DELEGATED APPLICATION REPORT

App Ref: PL/24/0635 Householder planning permission

Address: 17 Farrowdene Road, Reading RG2 8SD

Proposal: Construction of a front porch. (amended)

- Proposed Block Plan

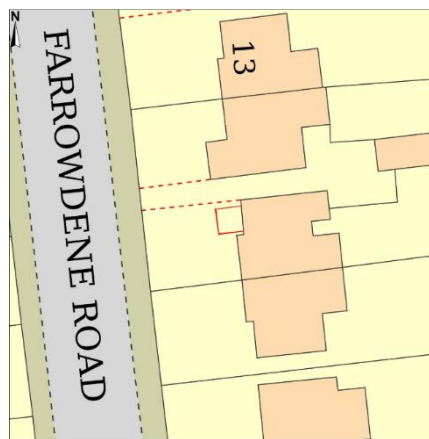
As mentioned, the dimensions and position of the proposed front porch are inconsistent across the submitted plans. The width of the proposed front porch in the proposed block plan is ca 213cm, while it is ca 270cm in other plans, showing a difference of around 57cm. In the proposed block plan, the depth of

Regarding the position of the proposed front porch, it is situated approximately to the north of the stepped front elevation, maintaining a gap from the side wall in the proposed block plan's front elevation. However, in the proposed front elevation (Existing and Proposed Side and Front Elevations), the front porch is shown as attached to the side wall. Moreover, the proposed development would overall be separate from the main house in the proposed house footprint.

Finally, the shape of the existing main house differs between the proposed block plan and the proposed plan (existing and proposed house footprint), making it challenging to cross-check the position of the proposed front porch. Therefore, it is difficult to understand the details of the entire proposal.

Proposed Elevation (Front)

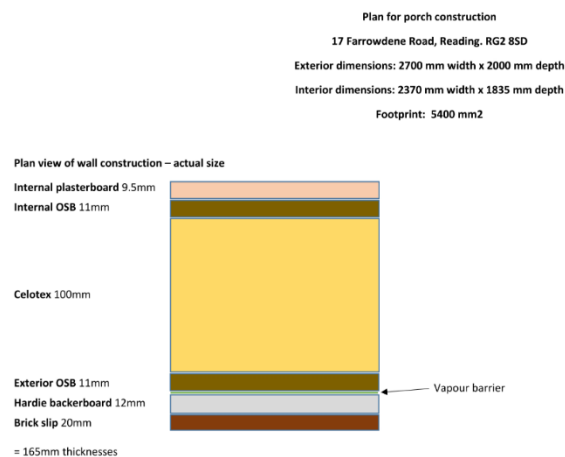
the proposed front porch is ca 210cm, whereas the depth of the proposed house footprint is ca 198cm, indicating a difference of around 12cm. The proposed total height measures 271cm, 279cm, 289cm in the proposed elevation (front porch), proposed side elevation and proposed front elevation, respectively, with the largest difference being 18cm.

'If the sketch is not a precise scale drawing, then that is due to the limitations of the computer software. The actual measurements we intend to build to are written on the plan. 2.700m wide, 2.000m depth and a height of 2.700m to the ridge of the apex. The door and glazing will be a standard, off the shelf product, circa 980mm wide and the side windows 300mm wide by 800mm high.' and,

Proposed Plan (Existing and Proposed House Footprint)

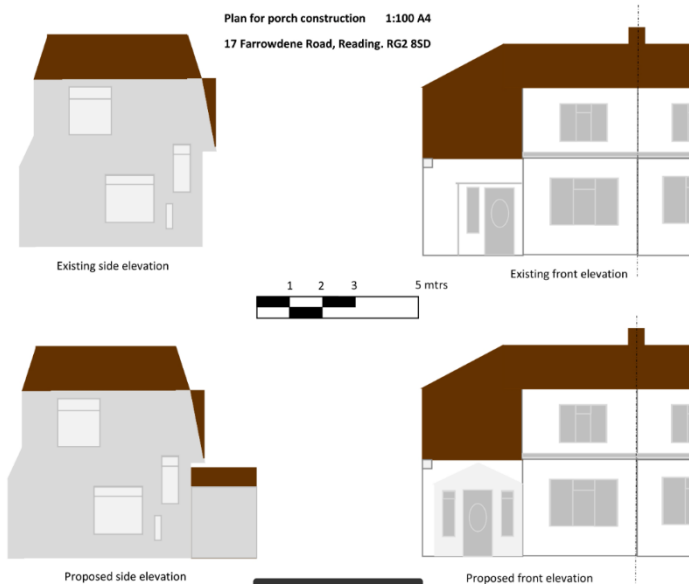
1. The submitted plans do not accurately show the proposed front porch. The dimensions and position of the proposed development are inconsistent within the submitted plans. The shape of the existing main house does not match between the proposed plan (Existing and Proposed House Footprint) and the proposed block plan. Insufficient detail is provided as to the appearance of the proposal. The application therefore fails to demonstrate that the proposal would respect the character and appearance of the house in terms of scale, location, materials and design and the character of the street as a whole. Contrary to Policies H9 and CC7 of the Reading Borough Local Plan 2019.

'There is to be no gap between the current protruding wall and the proposed wall of the porch.'
